Response to Submissions Report

State Significant Development Application 10479

200 Aldington Road Industrial Estate

Figure 3 Lot D (encroachment into the RE2 zone highlighted in yellow)

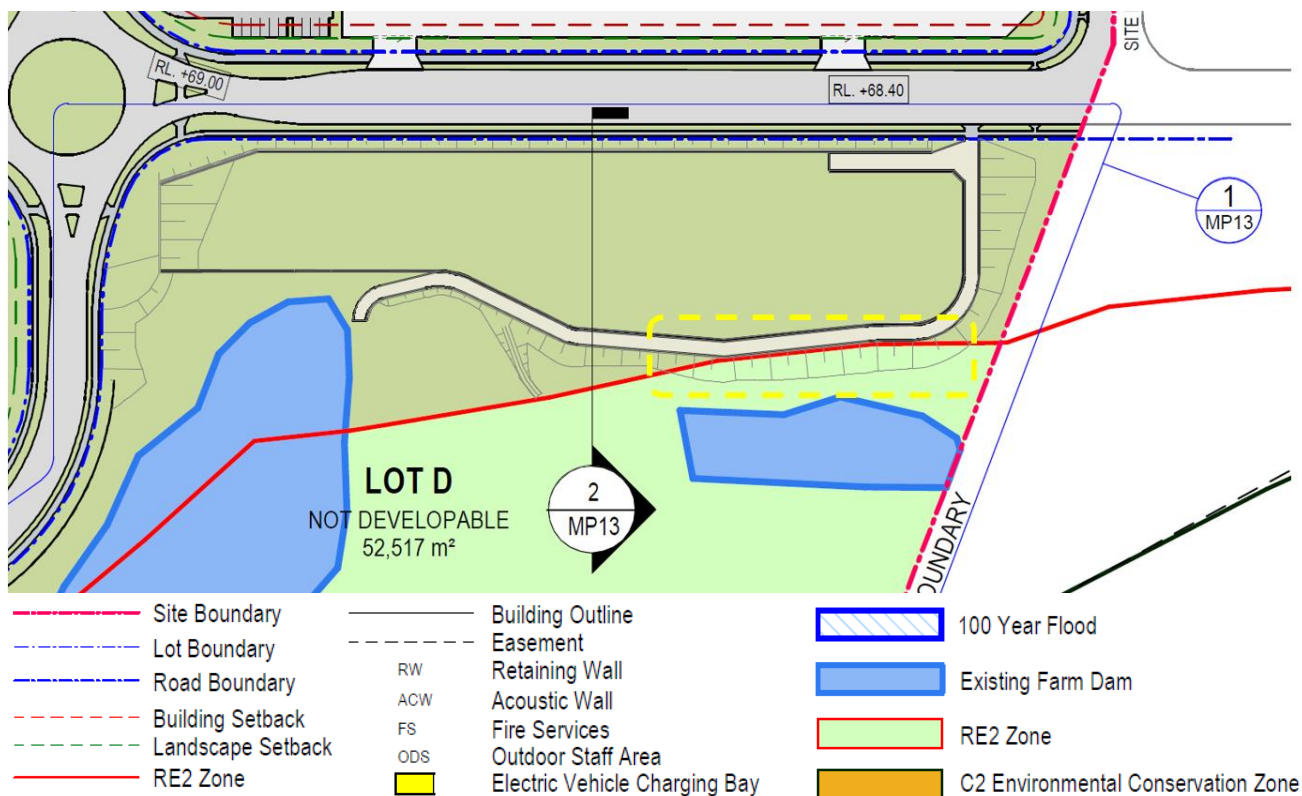
Comment

The Department notes there is a portion of earthworks proposed within the RE2 zone on Lot D, as shown on the Estate Masterplan. Please provide consideration of the permissibility of these works in the RE2 zone with regard to the zone objectives and land use table in Section 11 of WSEA SEPP.

The particular element which is encroaching the RE2 zone is the earthworks associated with the proposed maintenance track which will provide access to the RE2 zoned area in Lot D for on-going management of the riparian corridor areas under the Vegetation Management Plan.

The minor encroachment is shown within the dotted yellow line in **Figure 3**. The maintenance access track traverses around the edge of the bio-retention basin which is behind a retaining wall and wholly located in the IN1 zone. The primary purpose of the track is therefore associated with environmental protection. Under the RE2 zone of the SEPP, both *roads* and *environmental protection works* are permissible with consent.

Figure 4 R05 / Lot D Farm Dam Waterbody Section

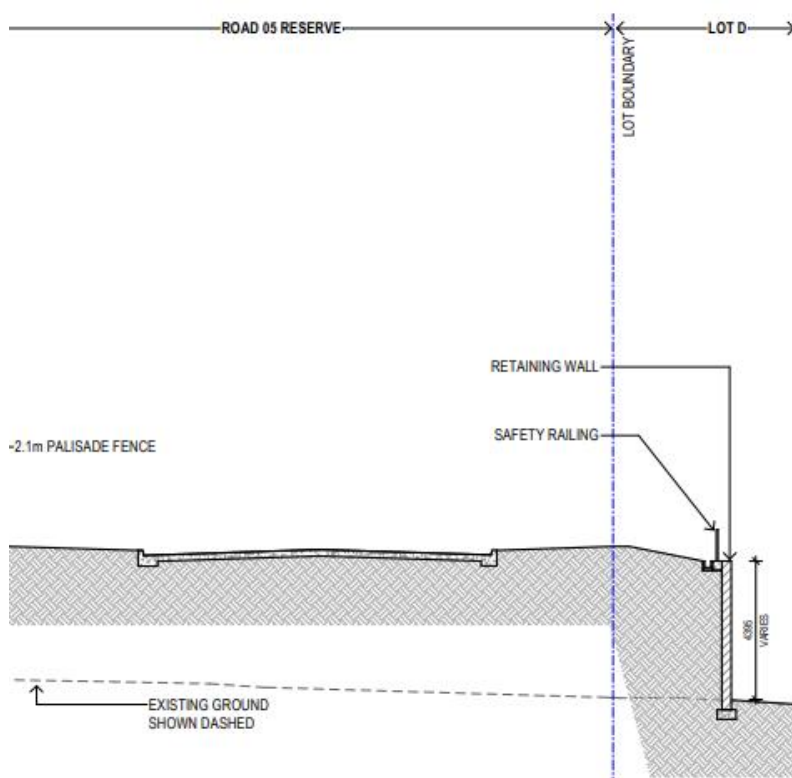
Comment

The Department notes the inclusion of the 'open space edge road' in the Concept and Stage 1 plans and proposed retaining walls between the road and RE2 zoned land. Consideration is to be given to the provisions of Section 4.4.1 and Control 23 in Section 3.4.1 of the draft MRP DCP with regard to levels and design of retaining walls adjoining the public domain.

The departure from this control is isolated to the north-east corner of the site. The proposed Park Edge Road (Identified as R05 on the Concept Masterplan) directly adjoins open space. The finished road level of R05 is proposed to be higher (approximately 3.6m) than the adjoining open space, separated by a retaining wall (refer to **Figure 4**). An assessment of the departure from Control 23 against Section 1.5.2 of the MRP DCP is provided in **Table 6**.

Matter for consideration	Response
<i>Why the controls are unreasonable or unnecessary in the circumstances</i>	<p>The departure from the control arises from three very deliberate and functional reasons:</p> <ol style="list-style-type: none"> 1. The level change between R05 and the open space ensures the overland flow and stormwater runoff does not concentrate or flow onto neighbouring development to the east of the site. 2. The level change also allows the overland flow and stormwater runoff from the road and northern catchment to flow down into the bio-retention B within Lot D. This in turn allows the stormwater to be treated onsite and adhere to the Integrated Water Cycle Management targets of the MRP DCP (section 2.4 of the MRP DCP). 3. The RE2 zoned land is within flood prone land. Road R05 will be constructed at a level higher than the 1% AEP and PMF which will provide safe access to development land to the east in flood events greater than the PMF. Thereby improving the function of the road.

Matter for consideration	Response
	<p>4. The retaining wall along R05 separates the pedestrian path from the adjacent waterbody (former farm dam) and reduces the risk associated with the public accessing the waterbody. A safety railing is proposed at the top of the retaining wall.</p> <p>On balance, the reasons mentioned above results in a far superior and more orderly road outcome compared to reducing the R05 road level to align existing levels of open space / RE2 zoned land solely to meet a more aesthetic aspiration of the MRP DCP.</p> <p>Importantly, we reiterate that the alignment of R05 has been designed to adhere to the preferred road network for the site under the MRP DCP. Adjusting the road alignment will thwart compliance with the preferred road network hierarchy of the MRP DCP.</p>
<p><i>How the development will achieve the aims and objectives of the DCP, Precinct Structure Plan, and Precinct Plan under the State Environmental Planning Policy (Western Sydney Employment Area) 2009 despite the proposed departure.</i></p>	<p>The proposal overall, and irrespective of the departure from Control 23, remains entirely consistent with the objectives of the I&E SEPP and this noncompliance does not thwart the proposal's ability to support economic activity and provide employment lands in the WSEA, support coordinated planning and regulatory efficiency in the WSEA, conserve biodiversity or heritage and provide development, which is logical, environmentally sensitive and cost effective.</p> <p>The proposal, irrespective of the non-compliance with control 23, is still consistent with the Mamre Road Structure Plan and continues to meet the objectives of the Structure Plan.</p> <p>Control 23 and its objectives, relates to road network, hierarchy and design. The level difference between R05 and the adjoining open space does little (if anything) to undermine the objectives of the Section namely:</p> <ul style="list-style-type: none"> • The road safety and efficiency and the minimisation of through traffic on minor roads; • The encouragement of public transport, bicycle or walking; • Safe and efficient access to Mamre Road; • Capacity to Mamre Road and the proposed Southern Link Road and better connectivity between precincts and parts of the WSEA; and or • The orderly and economic provision of road and intersection works. <p>The specific control, requires the following:</p> <ul style="list-style-type: none"> • <i>Public access to open space</i> – the adjoining land is RE2 and not proposed to be publicly accessible. • <i>Function of the road</i> – the retaining wall arrangement does not impact the road function • <i>Impact on existing vegetation</i> - no impact. • <i>Public amenity</i> - the retaining wall does not impact on the pedestrian pathway along Road R05. The retaining wall is a "cut wall" and will provide views across the waterbody. • <i>Public safety</i> – the retaining wall increases public safety by physically separating the public from the waterbody. • <i>Impact on ability to provide street tree planting</i> – no impact.

**Figure 5** Section of Lot D within the 1% AEP flood zone

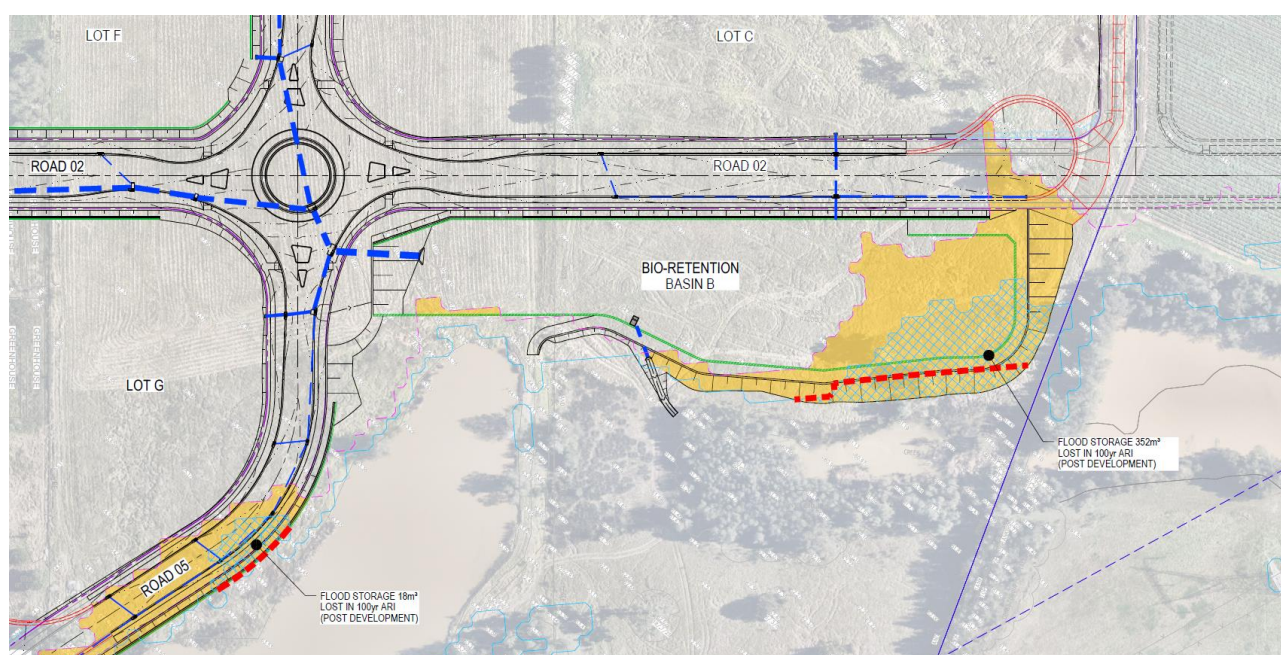
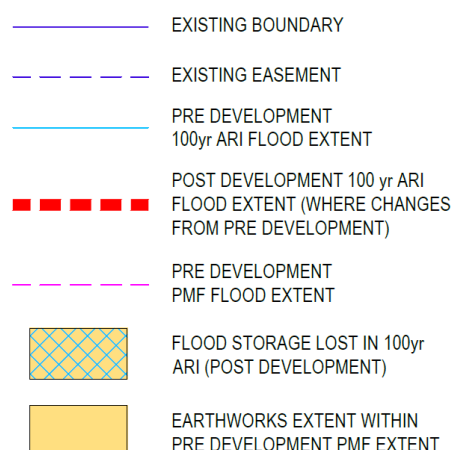
Comment

Section 6.3 of the RTS report advises that the basin on Lot D has been relocated outside of the 1:100 flood level. However, Figure 3 of the updated Flood Assessment shows parts of the basin within this area. Please clarify.

The proposal represents a technical departure from the abovementioned controls because Detention Basin B (within Lot D) has a minor encroachment into the 1% AEP flood zone (albeit being located entirely within the IN1 zone) (refer to blue hatched area within **Figure 5**). Part of Road R05 is also in the 1% AEP. Given Basin B is partly within the % AEP flood zone, it necessitates earthworks in the flood zone. The total volume of flood storage lost by these encroachments is 370m³ (refer to **Figure 5**).
